**TOWN OF LOS GATOS
PLANNING COMMISSION
REPORT**

ITEM NO: 4

DATE: March 7, 2025
TO: Planning Commission
FROM: Joel Paulson, Community Development Director
SUBJECT: Consider a Request for Approval to Demolish an Existing Single-Family Residence and Construction of a New Single-Family Residence, Remove Large Protected Trees, and Site Work Requiring a Grading Permit on Property Zoned HR-2½. **Located at 119 Harwood Court.** APN 527-56-027. Architecture and Site Application S-24-040. Categorically Exempt Pursuant to CEQA Guidelines Section 15303(a): New Construction or Conversion of Small Structures. Property Owners: Donal and Maire Conroy. Applicant: Gary Kohlsaat. Project Planner: Suray Nathan.

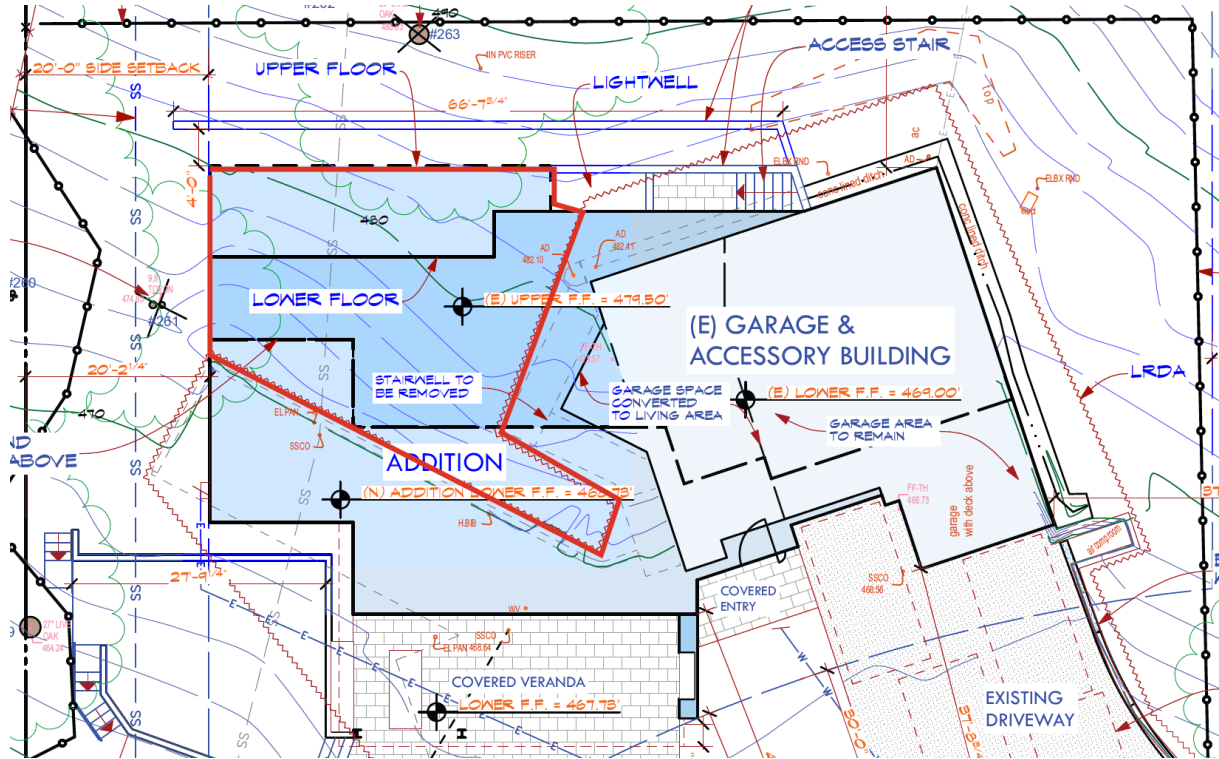
The HDS&G includes a standard requiring buildings to be located within the LRDA. The purpose of mapping the LRDA is to identify the most appropriate area or areas on the lot for locating buildings in the least constrained areas. Topography is one of the elements used to determine the LRDA, which has a slope limitation of less than 30 percent. A portion of the proposed building footprint would extend beyond the existing LRDA (Exhibit 10, Sheet A-4). In their Letter of Justification, the applicant indicates that before the existing structure was built, the entire lot had no areas with slopes less than 30 percent and the existing LRDA was created for the existing structure and the driveway. Additionally, the applicant states that any addition to the existing house would not be located in the LRDA unless the addition is a detached structure and hinders the functionality of the house (Exhibit 4). Due to site constraints, the applicant requests an exception to allow a portion of the building to be located outside of the limited LRDA.

The diagram below illustrates the area of the building that is proposed to be located outside of the LRDA, as highlighted by the bold red line.

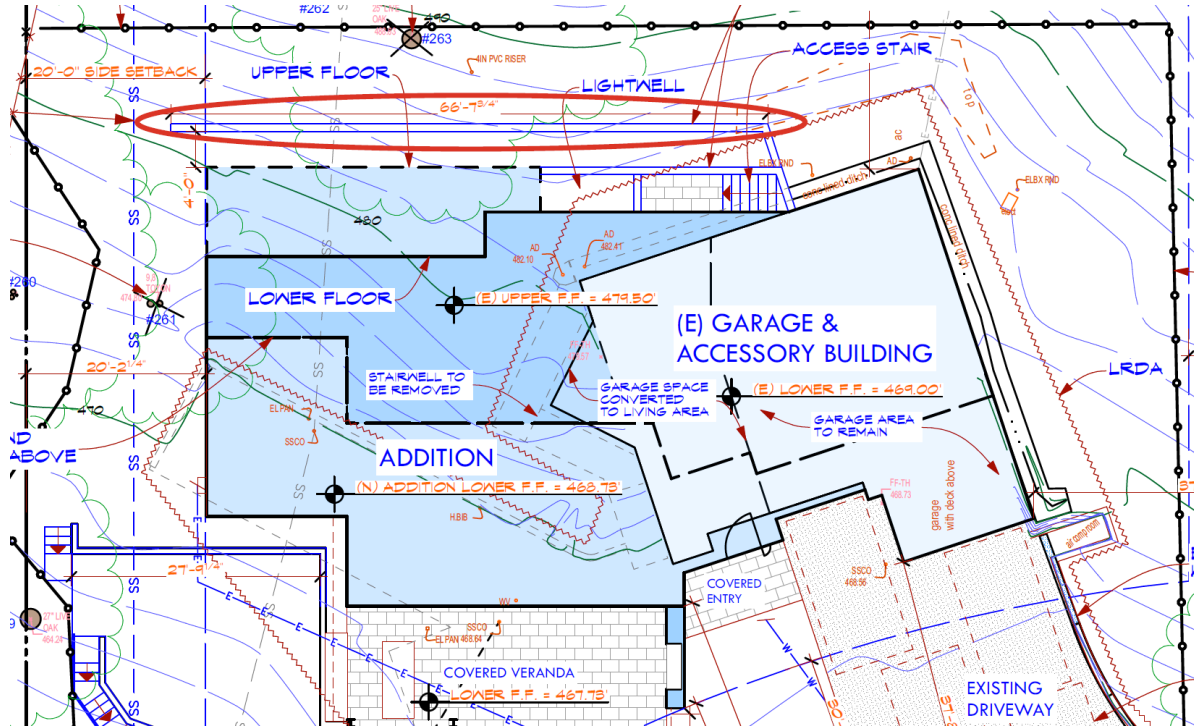
The Site Elements Section of the HDS&G includes a guideline requiring that retaining walls not run in a straight, continuous direction for more than 50 feet without a break, offset, or planting pockets to break up the long flat horizontal surface. A proposed retaining wall located approximately four feet from the rear of the residence, is approximately 67 feet long. The applicant notes in the Letter of Justification that the guidelines' intention is for aesthetic reasons. The proposed retaining wall is behind the residence and would not be visible and its purpose is to hold the hill back for more efficient drainage and safe access around the house. Additionally, the applicant states that providing a break in the wall would increase grading (Exhibit 4). The applicant requests an exception to allow the retaining wall to be longer than 50 feet.

The following diagram illustrates the location of the proposed 67-foot long retaining wall, as highlighted by the bold red line.
